City of Mississauga Department Comments

Date Finalized: 2022-09-28

Property Address: 1711 Coram Crescent

Appendix 1 – Transportation and Works Comments

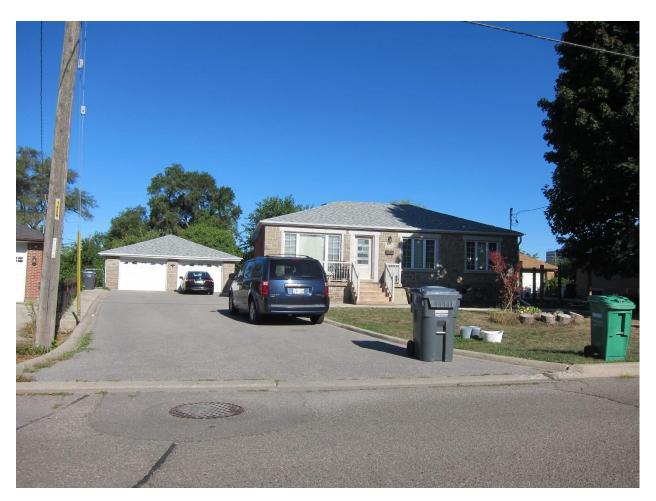
We are noting for Committee's information that any Transportation and Works Department drainage related concerns/requirements for the proposed addition will be addressed by our Development Construction Section through the future Building Permit process.
